**Canyon Fuel
Company, LLC**
A Subsidiary of Wolverine Fuels, LLC

Skyline Mine

RE: Removal of North of Graben Shaft from permit, Canyon Fuel Company, LLC, Skyline Mine,
C/007/005

Title: Removal of North of Graben Shaft

VEGETATIVE REFERENCE AREAS

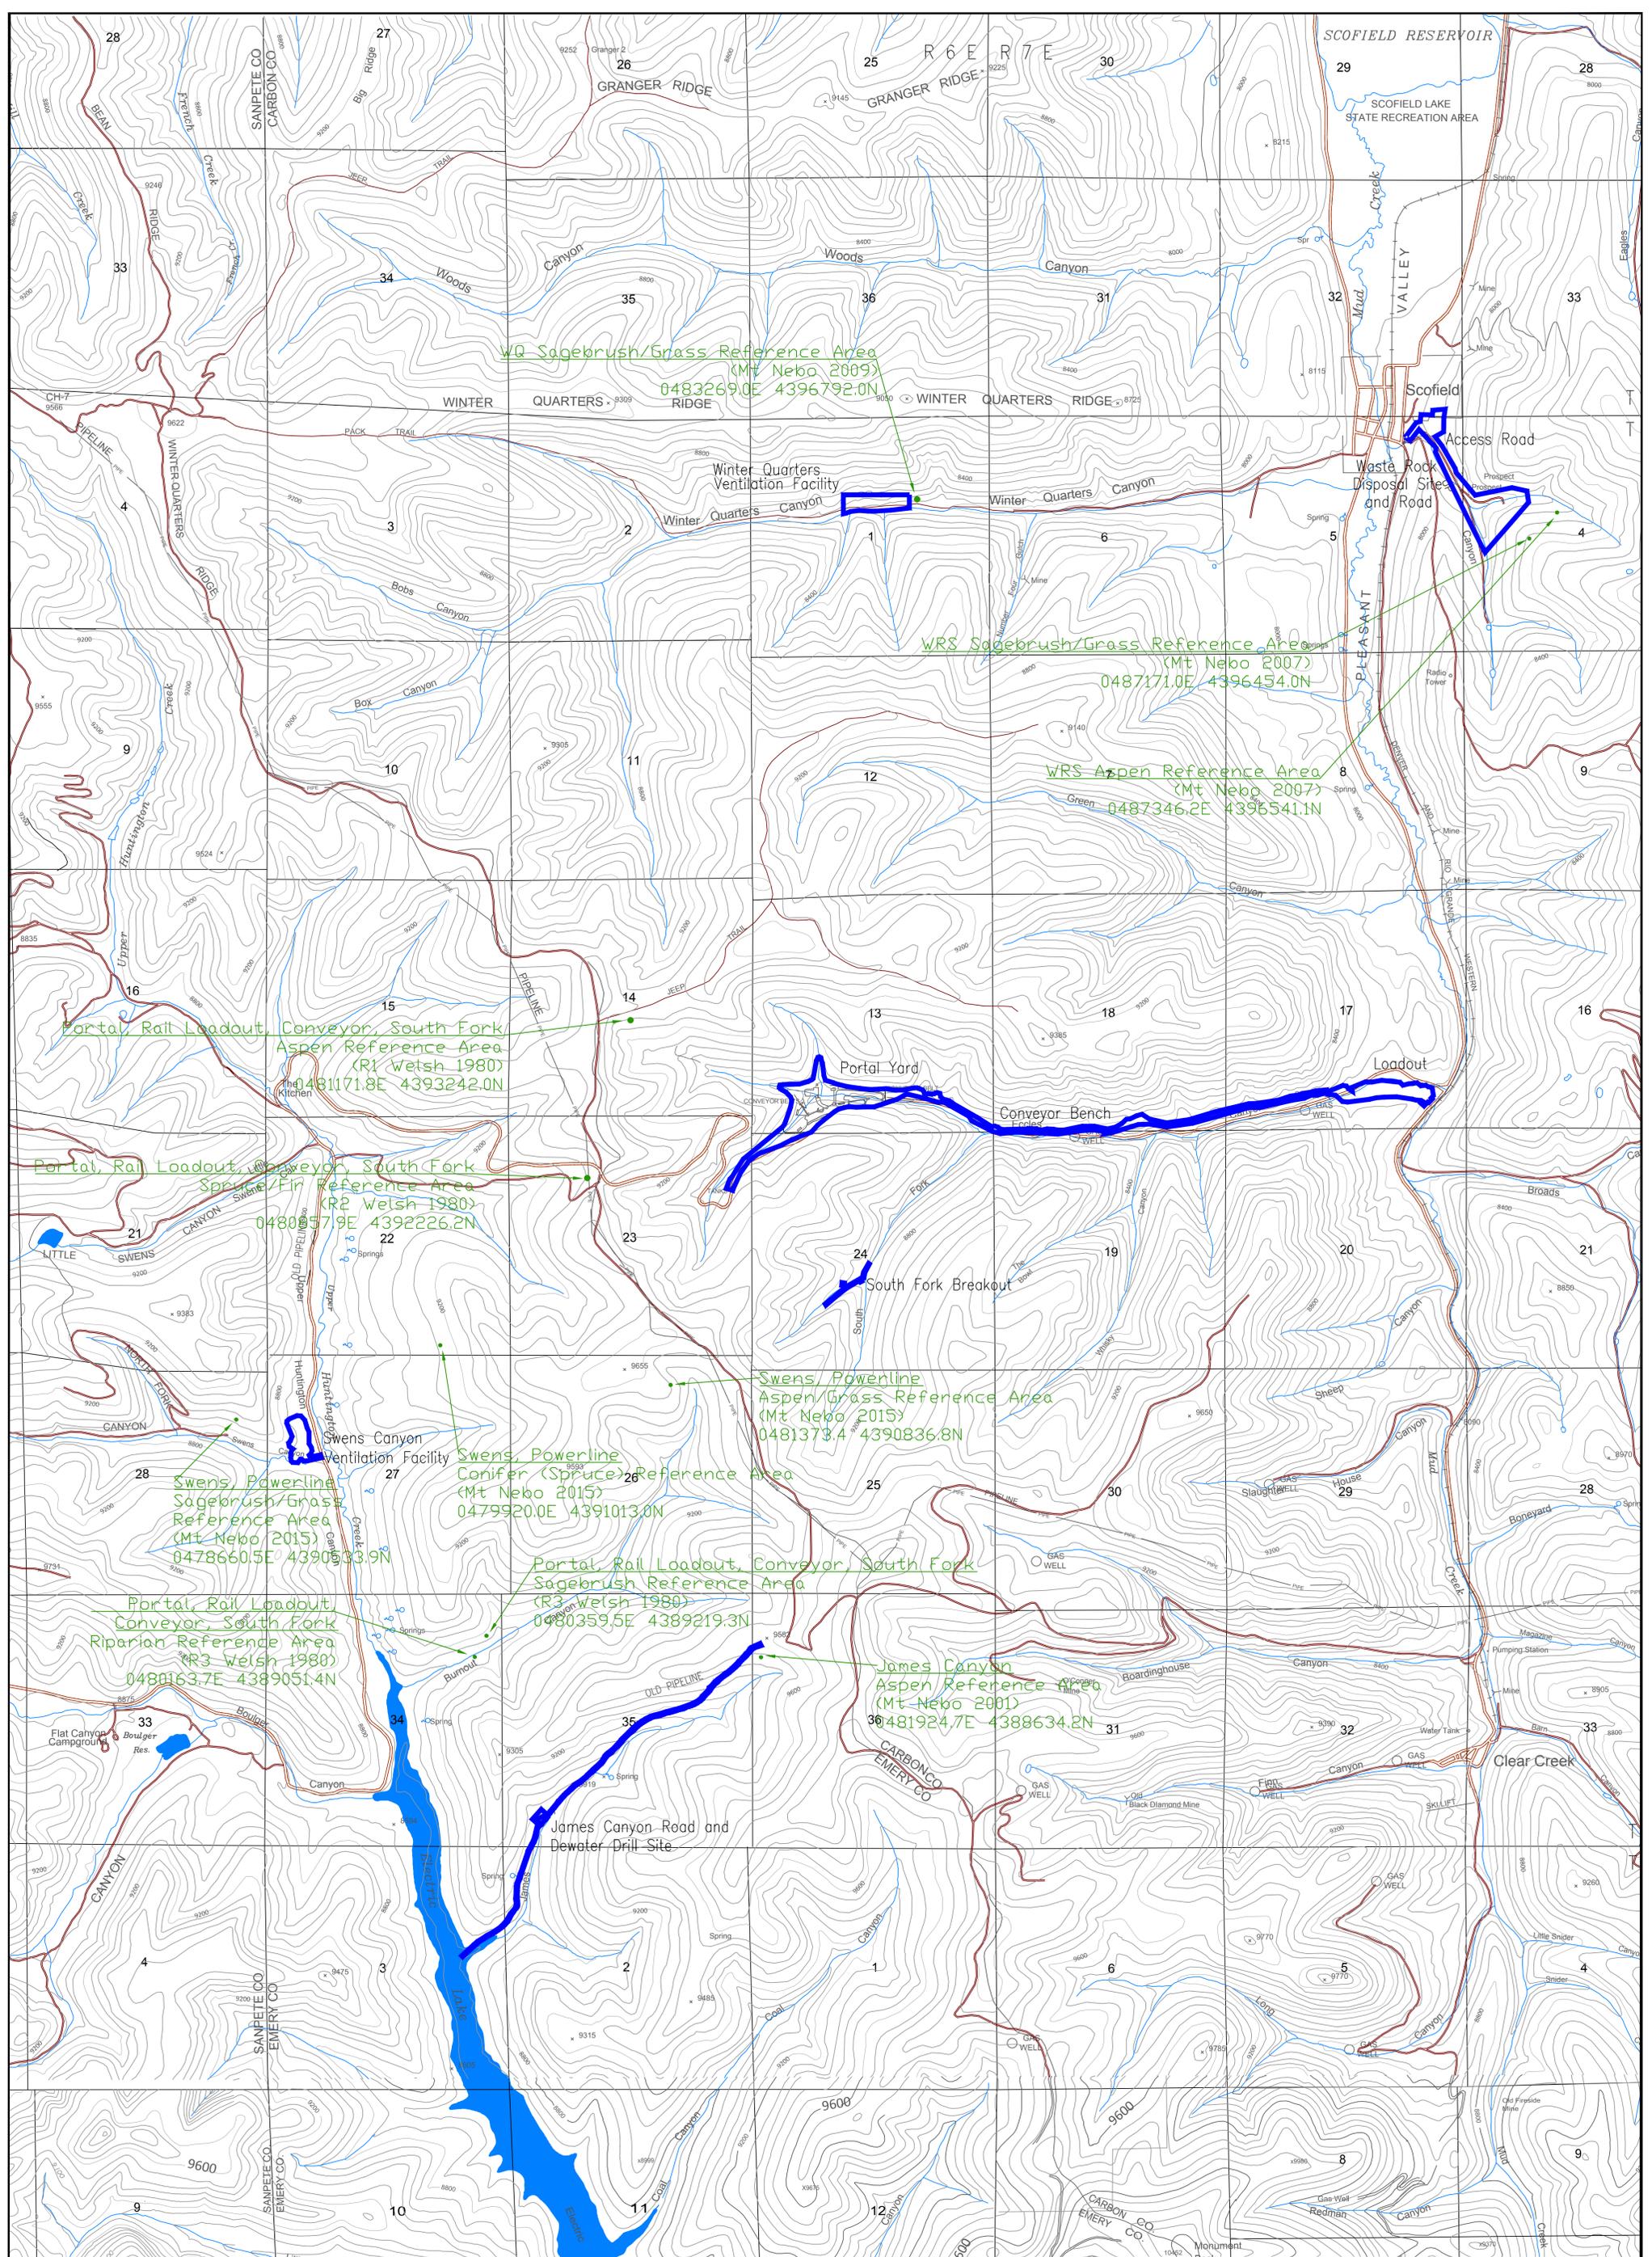
DATE	No.	REVISIONS	DR./G.C.
5/4/2016	1	Correct reference sites from all areas	JA/GC
12/20/2019	2	Correct reference sites GPS coordinates	TE/GC
1/2/2020	3	Removed NOG shaft	TE/GC
